Packet Guide
City of Charlottesville
Board of Architectural Review
Regular Meeting
January 18, 2023, 5:30 p.m.
Hybrid Meeting (In-person at CitySpace and virtual via Zoom)

BAR # 22-09-03

1301 Wertland Street, TMP 040303000

Project: New apartment building/existing Wertenbaker House c1830

Incorrect rendering (sheet 18 of submittal;)

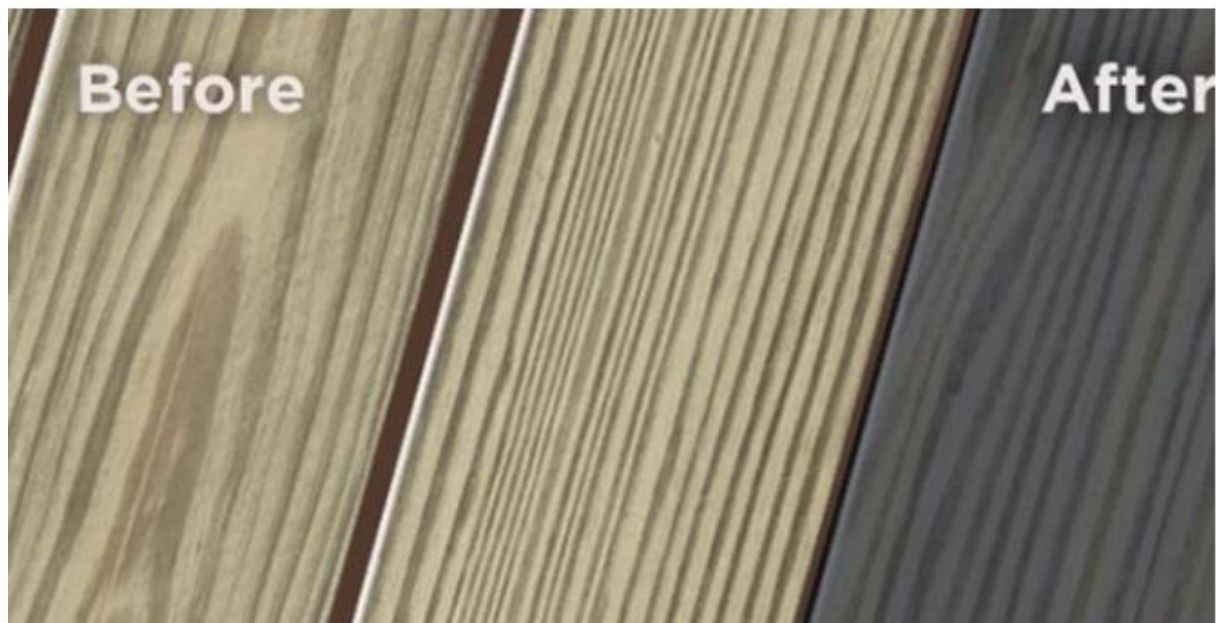
Note: The rendering on sheet 18 of the submittal is incorrect. Correct image is in the Appendix of this staff report.

Correct rendering

Canopy at garage entrance

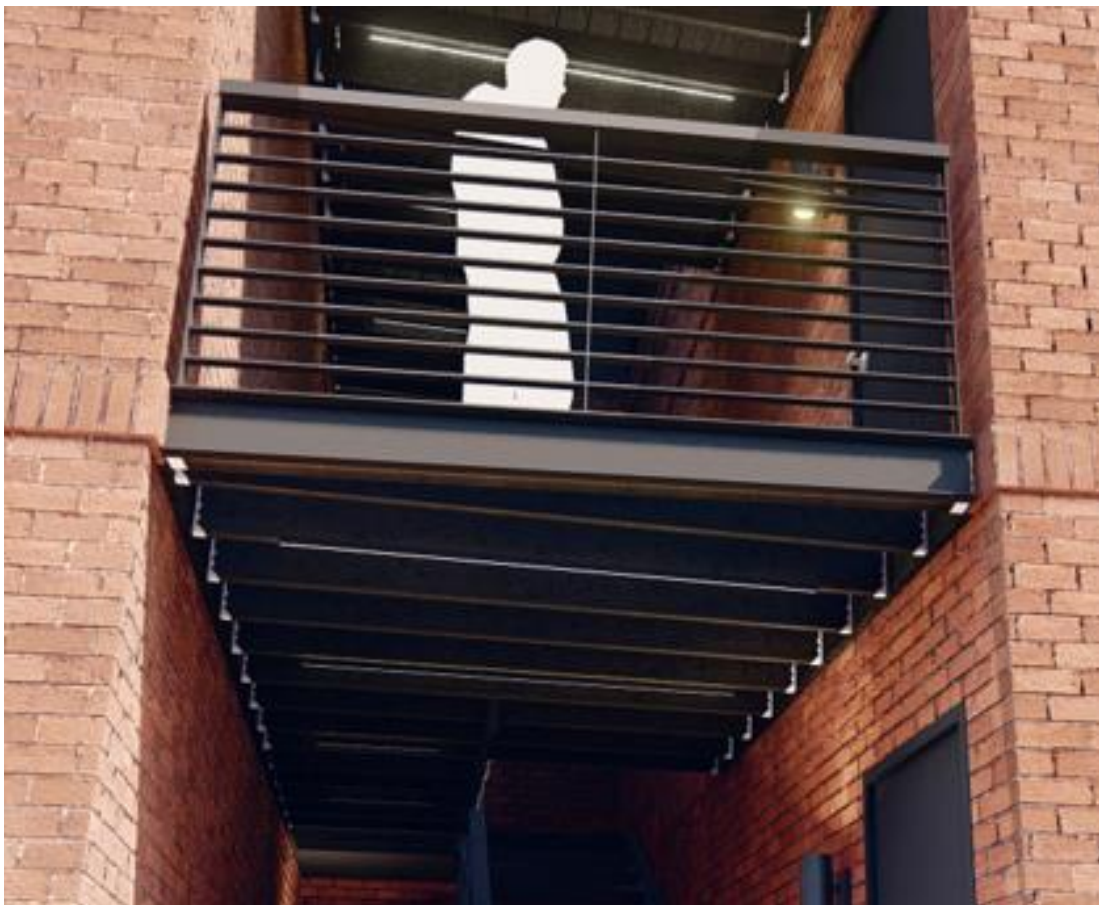
- Garage Door: None
- Canopy near garage entrance: (See image in Appendix.) Structural c-channels around the exterior (similar to balcony detail on Sheet 37). EPDM roof. Stained wood ceiling.
